Re: Recall No. 09V-059 Supplemental Information

MC 09-03

**MODEL:** 2008 and 2009 KLR™ 650 (KL650E8F/L, KL650E9F/L)

**TITLE:** MUFFLER MOUNT BOLT REPLACEMENT

## Replace Muffler Mount Bolts

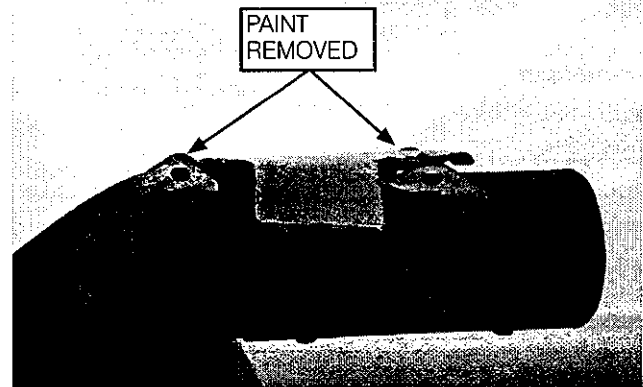
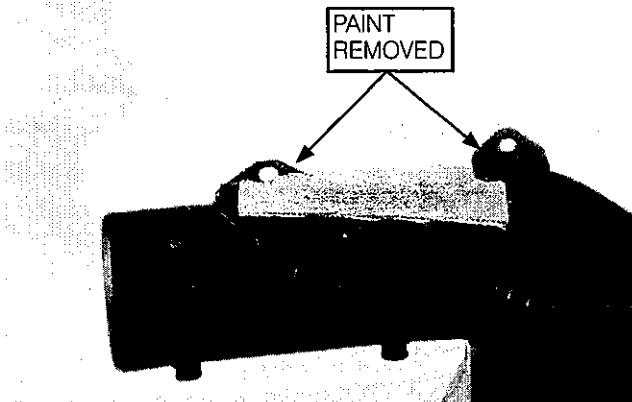
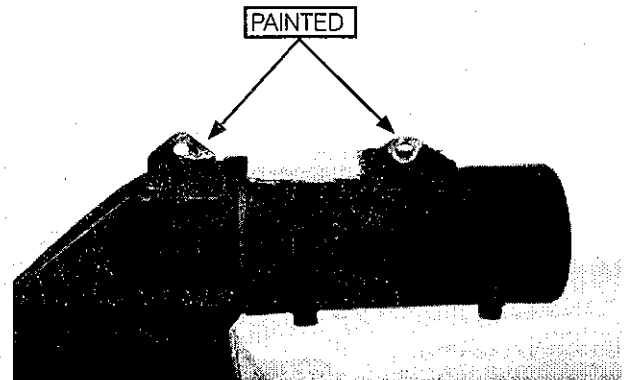
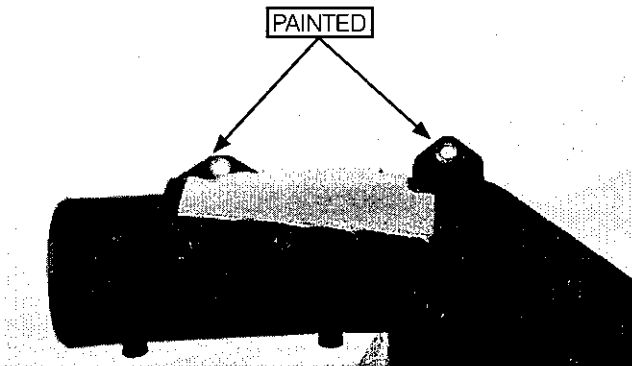
- Remove the muffler as outlined in chapter 5 of the service manual.
- Discard the muffler mount bolts and nut.
- Retain the muffler joint clamp and bolt.
- Discard the muffler joint gasket.
- Remove the paint from both sides of each (2) muffler mount tabs as shown. Use 100 grit sandpaper. Be sure to remove any welding spatter from the mount tabs.

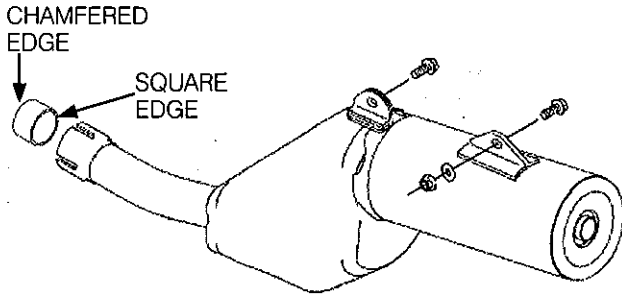
- o Install the chamfered edge of the muffler joint gasket facing forward.

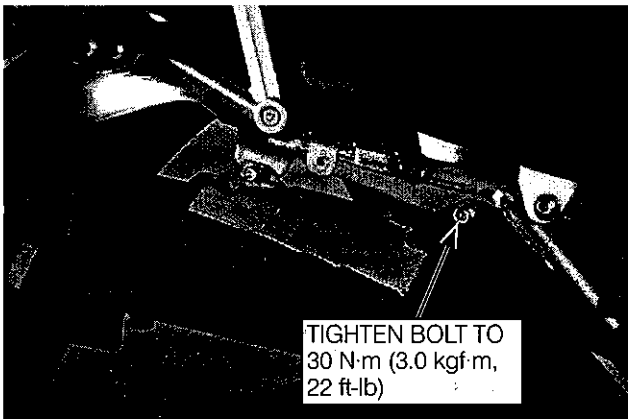
- o Install both bolts in the muffler mounts before tightening to insure the muffler is properly aligned..
- Tighten the forward muffler mount bolt to 30 N·m (3.0 kgf·m, 22 ft·lb).

- Tighten the muffler mount bolt and nut to 30 N·m (3.0 kgf·m, 22 ft·lb).

- Tighten muffler joint clamp bolt to 21 N·m (2.1 kgf·m, 15 ft·lb).

- Change the "muffler body mounting bolts" and "muffler body mounting nut" torque values in your service manual (99924-1384-01) to 30 N·m (3.0 kgf·m, 22 ft·lb) on pages 2-8, 5-5, and 5-43.
- Change the "muffler body mounting bolts" and "muffler body mounting nut" torque value in your service manual (99924-1384-02) for KL650E8F to 30 N·m (3.0 kgf·m, 22 ft·lb) on pages 2-7, 5-5, and 5-43.
